Model: <b>AP-P3</b>	Date: 28-Sep-12	No.: RM125001e
---------------------	-----------------	----------------

Subject: Firmware Release Note: Engine		Prepared by: Y. Urushihara	
From: 1st Tech Service Sect., MFP/Printer Tech Service Dept.			
Classification:	<input type="checkbox"/> Troubleshooting <input type="checkbox"/> Mechanical <input type="checkbox"/> Paper path <input type="checkbox"/> Product Safety	<input type="checkbox"/> Part information <input type="checkbox"/> Electrical <input type="checkbox"/> Transmit/receive <input checked="" type="checkbox"/> Other (Firmware)	<input type="checkbox"/> Action required <input type="checkbox"/> Service manual revision <input type="checkbox"/> Retrofit information <input checked="" type="checkbox"/> Tier 2

Model: AP-P3		Date: 28-Feb-13	No.: RM125020
Subject: SC573 or the surface of fusing belt peeling off		Prepared by: H. Tamaki	
From: 1st Tech Service Sect., MFP/P Tech Service Dept.			
Classification:	<input checked="" type="checkbox"/> Troubleshooting	<input type="checkbox"/> Part information	<input type="checkbox"/> Action required
	<input type="checkbox"/> Mechanical	<input type="checkbox"/> Electrical	<input type="checkbox"/> Serv

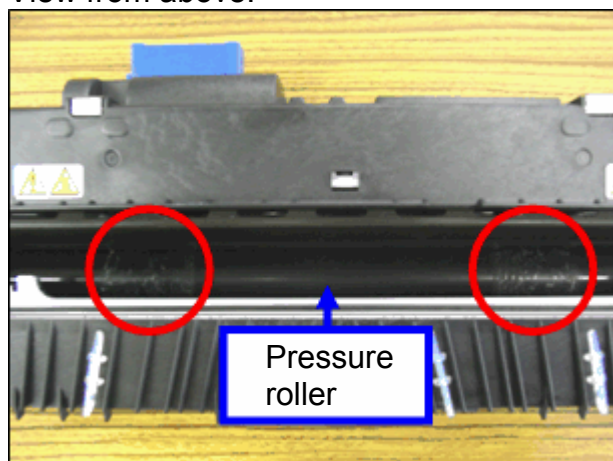
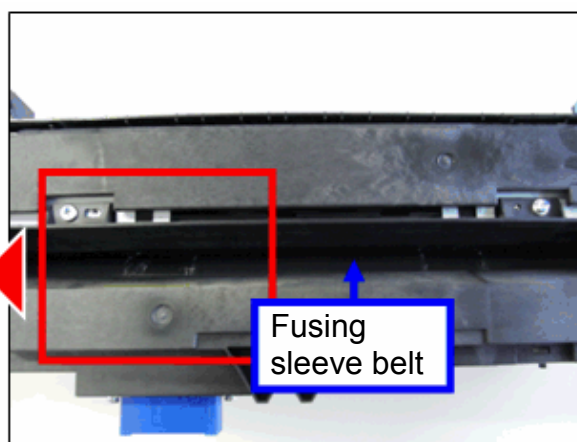
SC573 occurs or part of the surface layer of the fusing sleeve belt peels off.

- The width of the paper is 206mm or less, or
- The paper size setting is different from the size of the paper loaded in the tray

The print speed is not reduced at the optimal timing nor to an optimal degree for paper types with widths of 206mm or less. As a result, the fusing temperature is relatively high.

The locations of the sensors that monitor the paper are different for each paper width. In this case, the section of the belt with the highest temperature cannot be watched.

Update the Engine firmware to the following version or newer if the symptom occurs, or at the next service visit (EM prevention):

Ver. 1.02:02

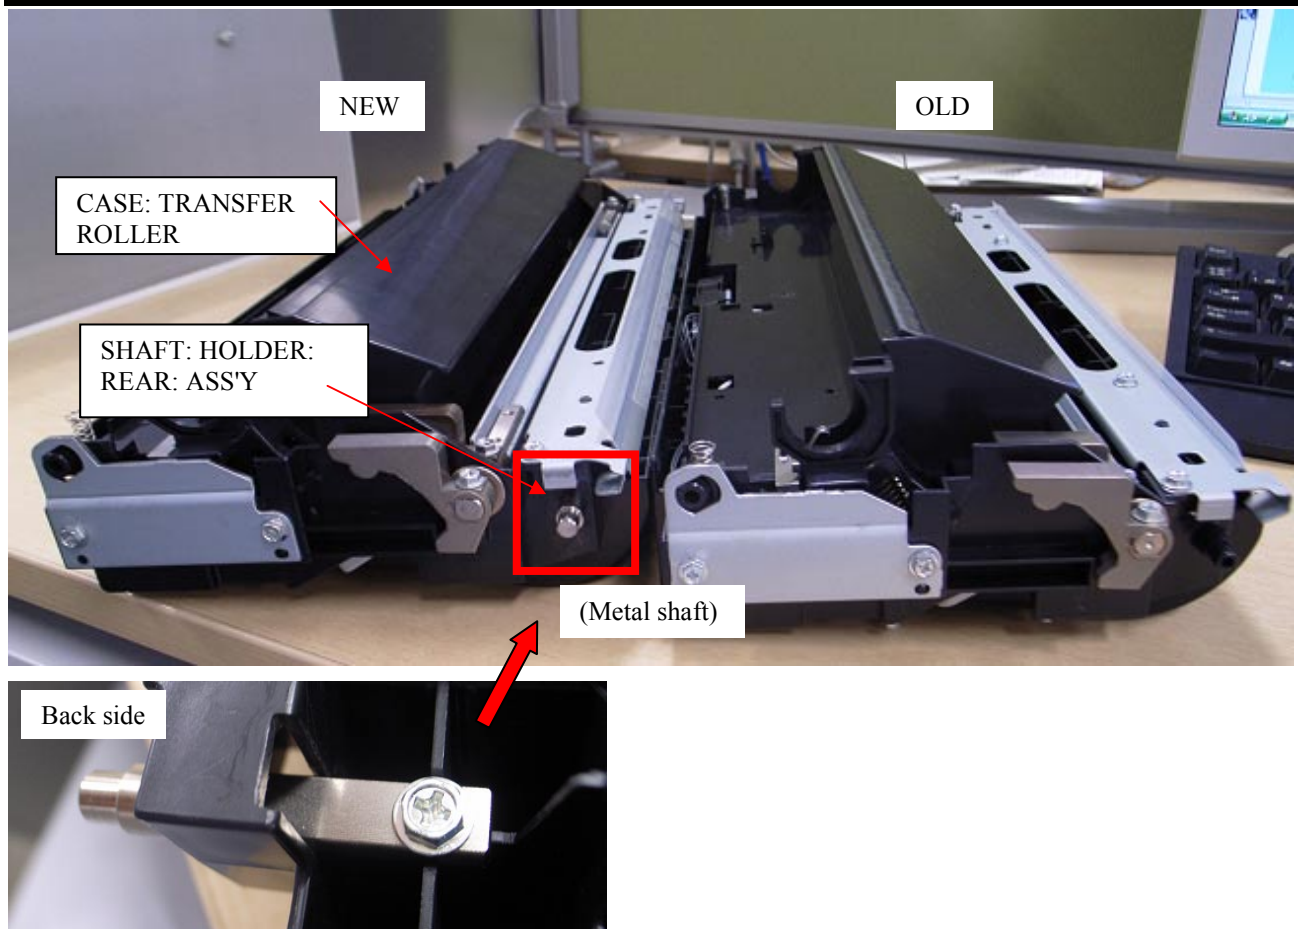
**Change:** The material of the parts was changed from a resin to a metal.

**Reason:** To further increase the load-bearing strength of the parts.

**Important:** Interchangeability is **X/O as a set** (all six parts together).

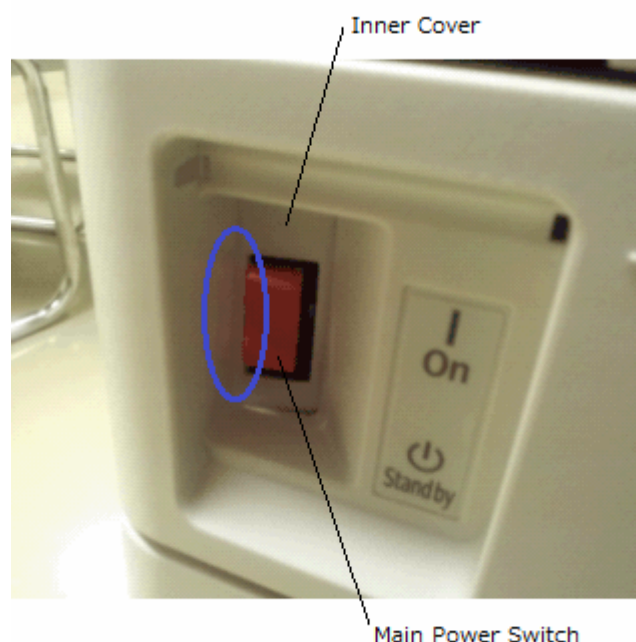
SC672-10 (Connection Error) is displayed, and/or SC819 is logged

The gap between the inner cover and main power switch is too narrow, due to combined margins of error in the surrounding parts. As a result, when the ECO Night Sensor is enabled, the solenoid cannot turn off the main power switch and the controller logs SC819 (shut down count over). After this, SC672-10 (connection error) is displayed.

**SOLUTION**

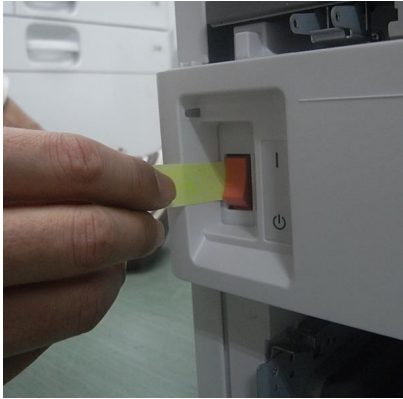
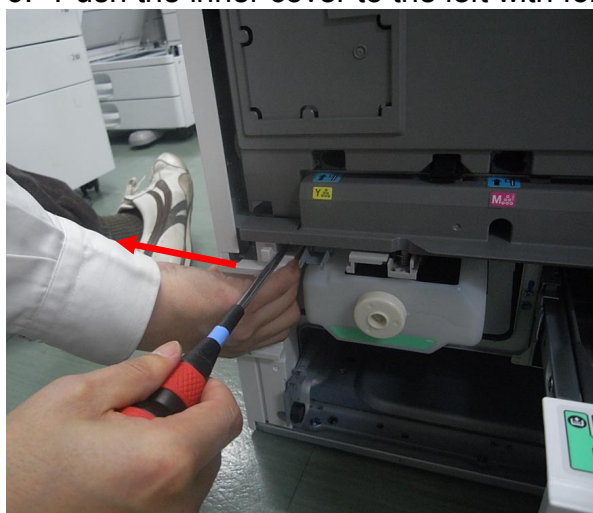
1. Check the gap between the inner cover and power switch by inserting a piece of paper with the thickness of a business card (0.2mm – 0.3mm).

2. If you cannot insert the paper into the gap, this means that the gap is too narrow. Reinstall the inner cover (screws x 2) as shown in the steps below.

3. Remove the second tray.

4. Remove the front door.

5. Pull out the first tray and remove the left-front cover.

6. Push the inner cover to the left with force and fasten the screws.

**Production line**

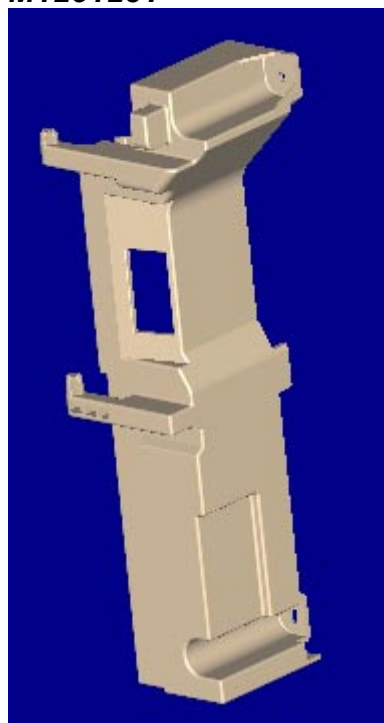
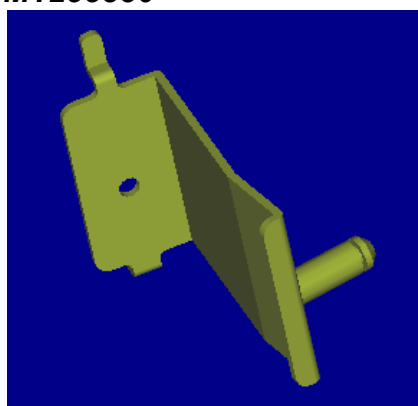
The inner cover was changed to improve the combined margin.

Old part number	New part number	Description	Q'ty	Int	Note
M1251230	M1251231	INNER COVER:LEFT:P3	1	X/O	-
<b>B2385821</b>	<b>M1255830</b>	<b>BRACKET:HANDLE:MAIN SWITCH:PEEN</b>	<b>1</b>	<b>X/O</b>

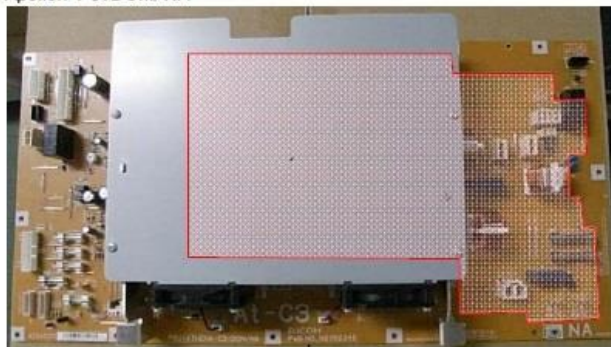
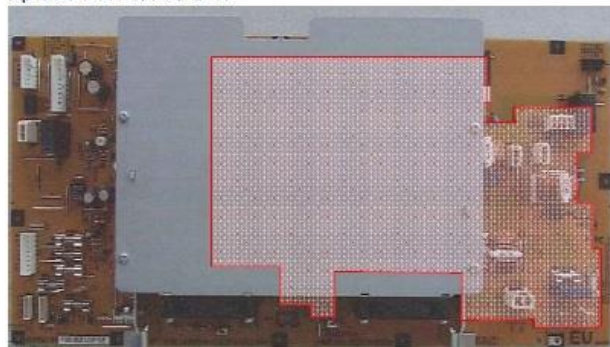
**NEVER touch** the areas outlined in red in the photos below to prevent electric shock caused by residual charge.

Residual charge of about 100V-400V remains on the PSU board for several months even when the board has been removed from the machine after turning off the machine power and unplugging the power cord.

The areas outlined in red on the bracket mean the residual charge of about 100V-400V remains on the PSU board under the bracket.
